APPLICATION NO.	FILING DATE	FIRST NAMED INVENTOR	ATTORNEY DOCKET NO.	CONFIRMATION NO.
10/777,560	02/11/2004	Harry S. Luan	108-18.1	5757

Office Action Summary

DETAILED OFFICE ACTION

FIG. 2

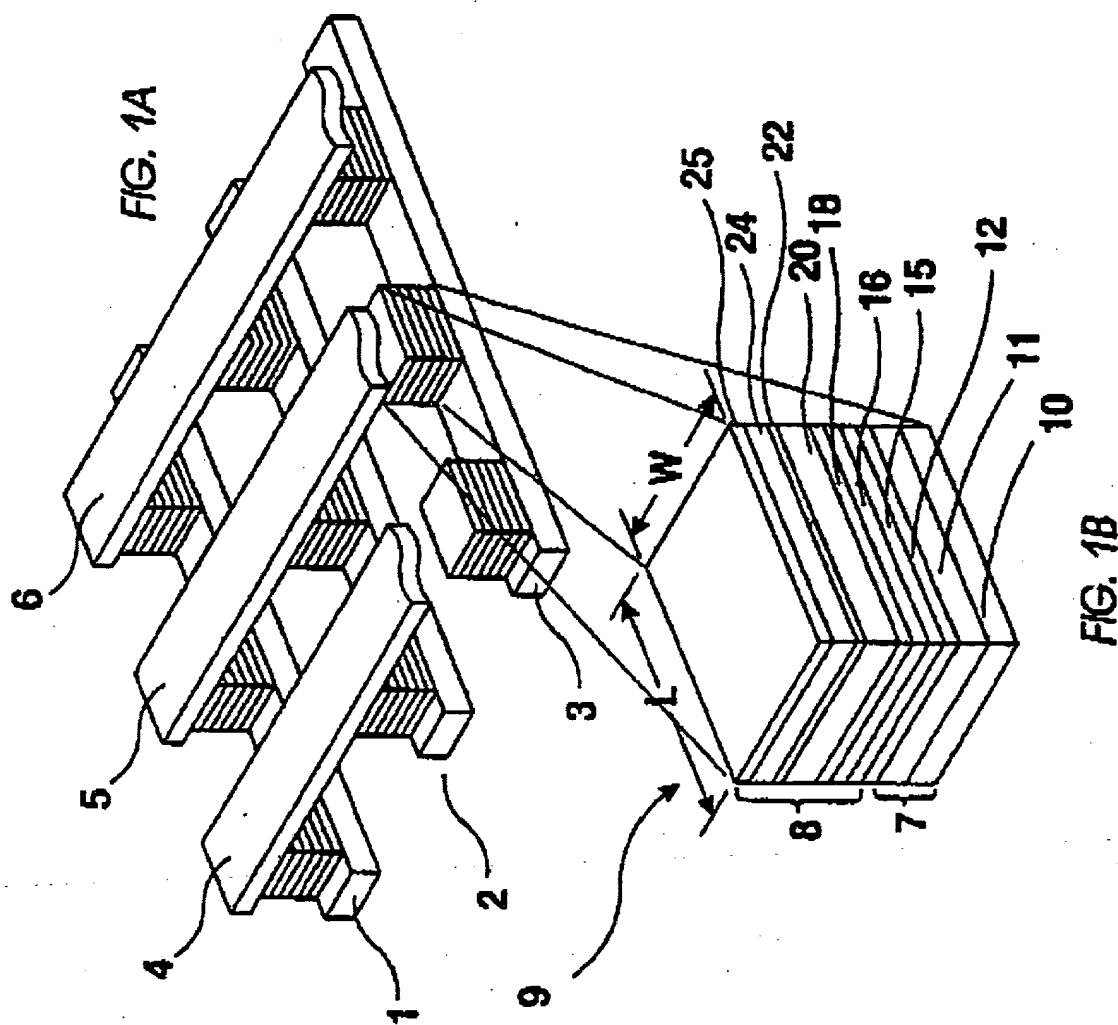
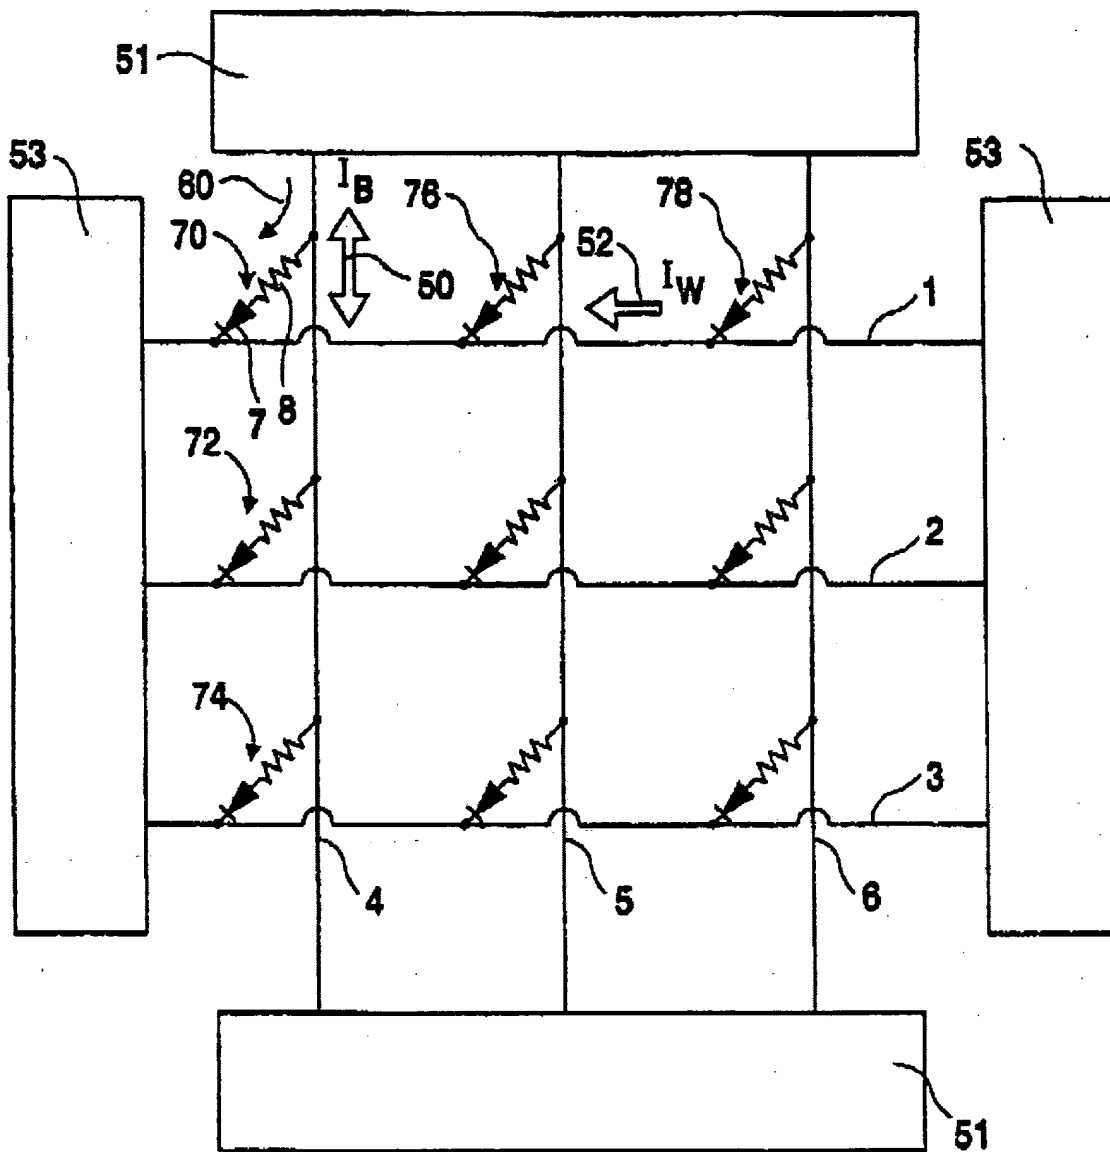
Gallagher discloses (fig 1A, Fig 2) an integrated circuit comprising: a first array of memory cells, each memory cell in the first array comprising a resistive element (column 2 lines 33-34) and a Schottky diode (column 10 line 61-64) coupled in series and having first and second terminals; a first plurality of bit lines, one bit line for each column of the first array, each bit line coupled to the first terminal of memory cells in a respective column of the first array; and a first plurality of word lines, one word line for each row of the first array, each word line coupled to the second terminal of memory cells in a respective row of the first array.

Gallagher discloses (fig 1A, Fig 2) a memory arrays with cells that are formed at cross-point between a bit line and a word line.

Gallager discloses (fig 1A, Fig 2) all the invention including a schottky switching element except for the specific detail that the schottky diode are made of amorphous silicon. This feature , however, is considered obvious since the use of schottky diode made of amorphous silicon is old and well known in the art as evidenced by the disclosure by Shanks (US patent 4,203,123) in fig 3B and in column 4 lines 5-11.

**FIG. 1**

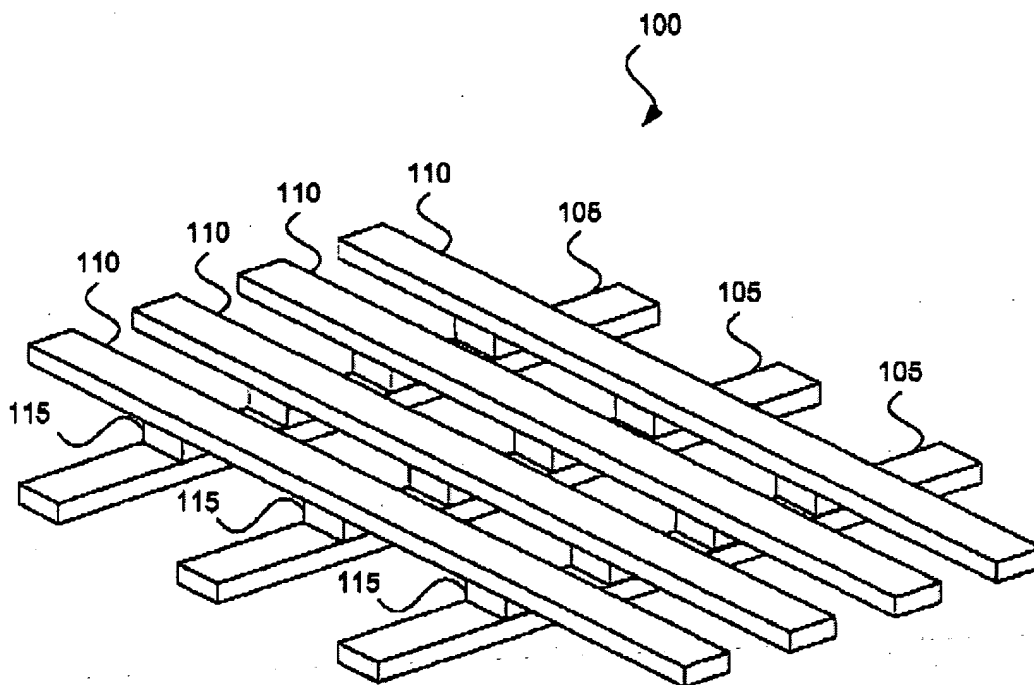
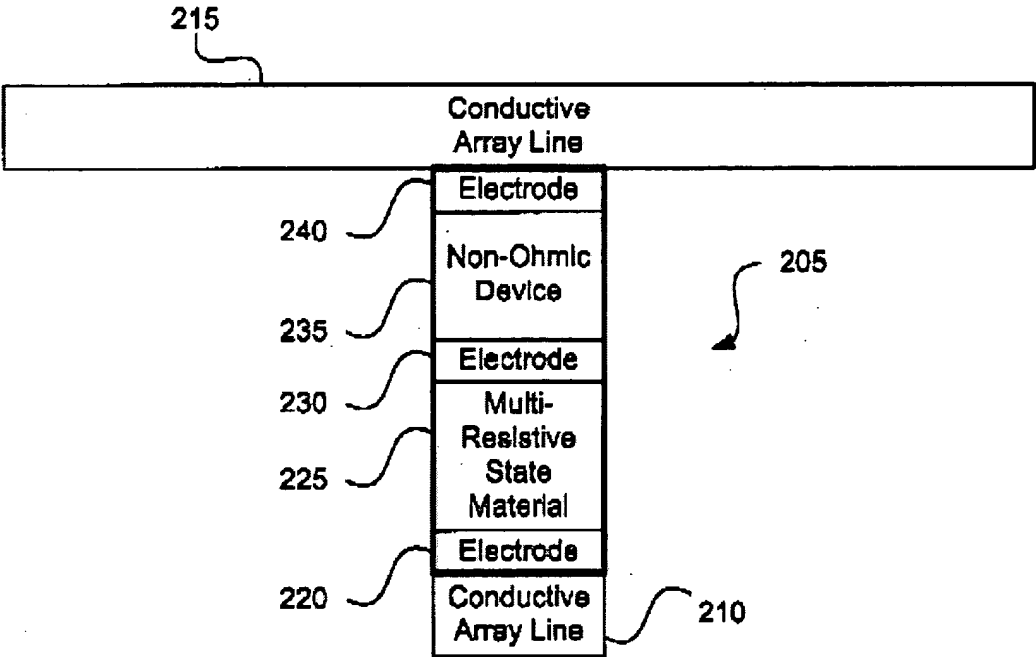
Rinerson (the abstract, fig 2, fig 5, column 5 line 27-45) discloses all the invention including a perovskite PCMO ($\text{Pr}_{0.7}\text{Ca}_{0.3}\text{MnO}_3$) resistive material.

Rinerson (column 4 lines 25-32,column 5 lines 27-45) discloses the use of Perovskite Colossal resistive material.

FIG. 3

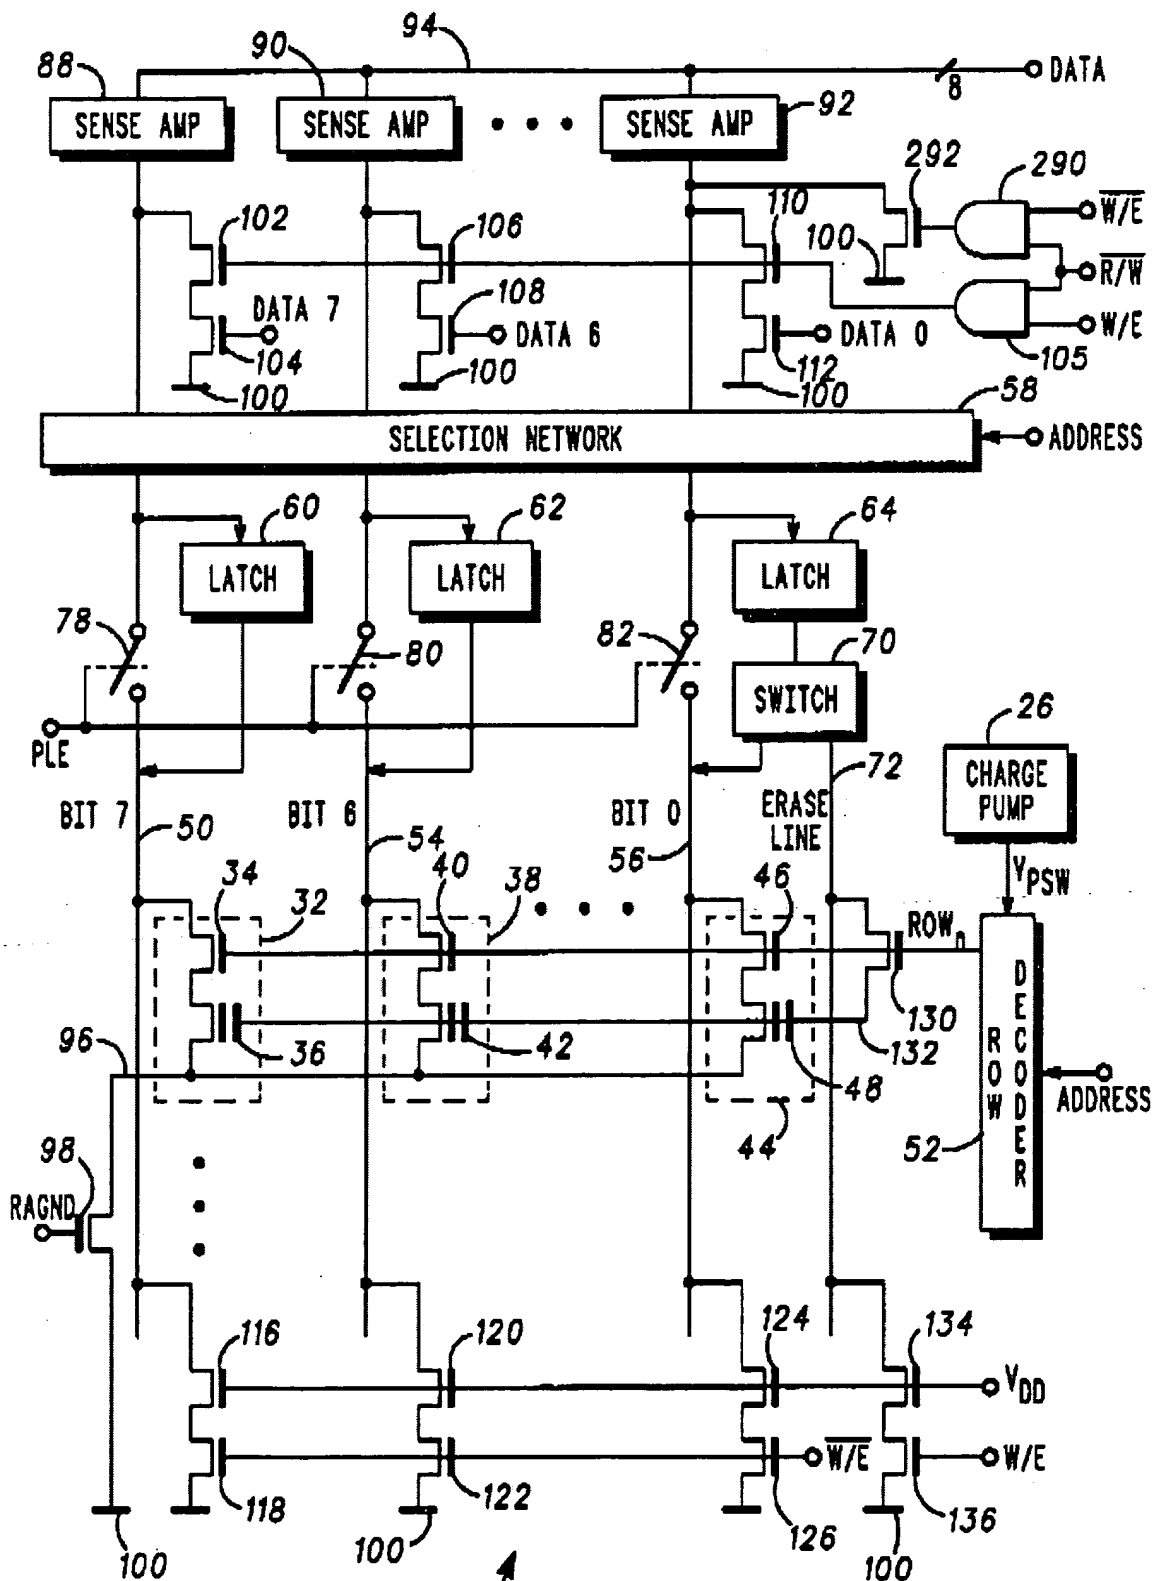
Marquot discloses (in fig 3,column 3 lines 42-50) a word line decoder (Marquot called it the row decoder) for reading and programming the memory cell. Noted that on top of the row

decoder in fig 2 there is a charge pump 26 that can be used among other thing to program the memory cells.

Marquot discloses (in fig 3) disclose a plurality of sense amplifiers (reference 88,90,92) Those are coupled to the bit lines to read the state of the memory cells.

The combined teachings by Rinerson 939 and Kim disclosed all the invention except going into detail about the use of decoder and sense amplifiers. These features, however, are considered obvious since they are old and well known in the memory art as evidenced by the disclosure by Marquot (fig 3).
